From: Chad Croft – ecoLogical Solutions

RE: Minute 2 of Expert Panel Ashbourne FTAA -2507-1087

Figure 1: Flood modelling – Waitoa River at Ashbourne site (Maven 2025).

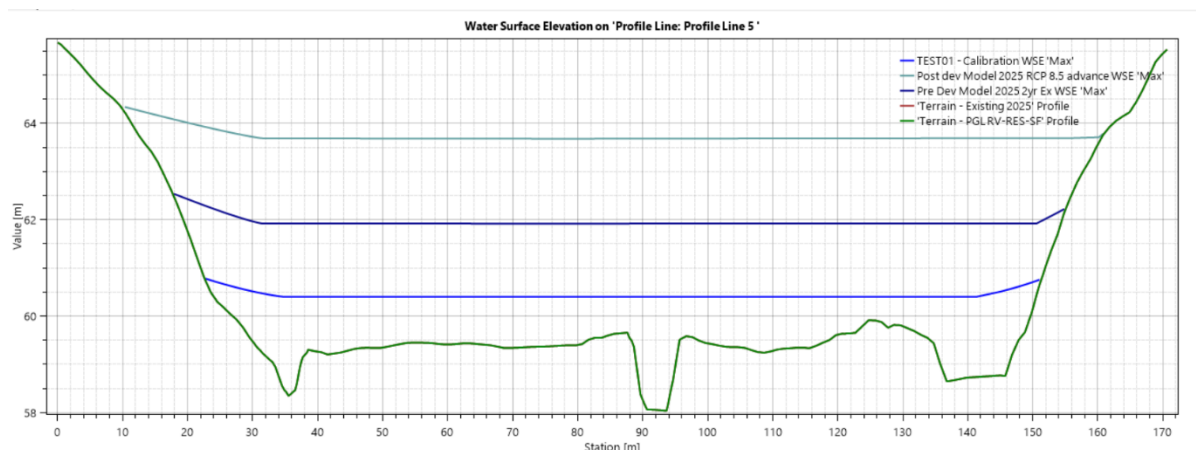
(i) The effects on the Oxbow lakes of the existing drain being diverted away from these lakes and discharging into the Waitoa River.

The primary hydrological influence on the oxbow wetlands is thought to be the Waitoa River (Clare Houlbrooke WGA, personal communication October 22, 2025). Flood modelling undertaken by Maven shows that Oxbow wetland 2 is mostly inundated during the 2yr ARI and completely during the 10 yr ARI (Figure 1). Oxbow wetland 2 has an RL of c. 59-60 m. Flood modelling indicates the regular storm event based on data from a gauge downstream is 60.04 m while the 2yr event has a water surface level (WSL) of 61.92 m and the 100yr event has a WSL: 63.68 m (Maven 2025).
